APPLICATION NO.	FILING DATE	FIRST NAMED INVENTOR	ATTORNEY DOCKET NO.	CONFIRMATION NO.
09/975,630	10/12/2001	Taylor R. Efland	TI-31678	8387

Office Action Summary	Application No. 09/975,630	Applicant(s) EFLAND, TAYLOR R.	
	Examiner Leonardo Andújar	Art Unit 2826

- 1) ☒ Responsive to communication(s) filed on 26 July 2004.
- 2a) ☒ This action is **FINAL**. 2b) ☐ This action is non-final.
- 3) ☐ Since this application is in condition for allowance except for formal matters, prosecution as to the merits is closed in accordance with the practice under *Ex parte Quayle*, 1935 C.D. 11, 453 O.G. 213.

FIG. 1

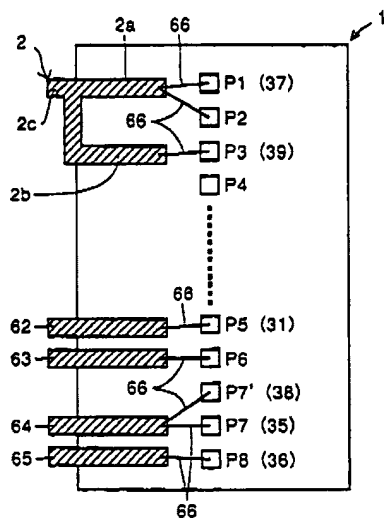
5. Regarding claim 1, Yamasaki (figs. 1-5) discloses a chip 71 having a first and second major opposing surfaces, a circuit having active components such as MOS transistor 70, and a protective overcoat 6 over the first chip surface. Yamasaki, also, shows a network of substantially coplanar power distribution lines 25 laterally disposed on the first surface of the chip over the overcoat and located directly over active

components of the circuit. The lines are conductively connected to the selected active components below the line in a direction normal to the first surface through vias 10 in the overcoat. Moreover, conductors 2b are connected to segments 2c of the lead frame (see fig. 1). As shown in figure 1, conductive members 66 directly connect the power distribution lines to connection regions external to the chip.

26. Applicant argues that that amended claims 1 and 2 are not taught by the prior art. Nonetheless, Yamasaki shows all the claimed limitations such as a network of substantially coplanar power distribution lines 25 disposed on the first surface of the chip over the overcoat 6 (see fig. 2B). Also, Yamasaki shows vias (e.g., 10) connecting the lines and the active components, and electrically conductive members such as directly connecting the power distribution lines to connection regions external the chip (e.g., 2a). Applicant argues that structure disclosed by Yamasaki is a single transistor structure. Nevertheless, Yamasaki teaches more than one transistor as clearly shown in figure 2b. Note that a sectional view means that the represented unit is repeated. This type of representation is used to avoid redundancy. Moreover, the top view evidenced that more than one transistor are used since several pairs of source/drain electrodes are depicted in figure 2A.
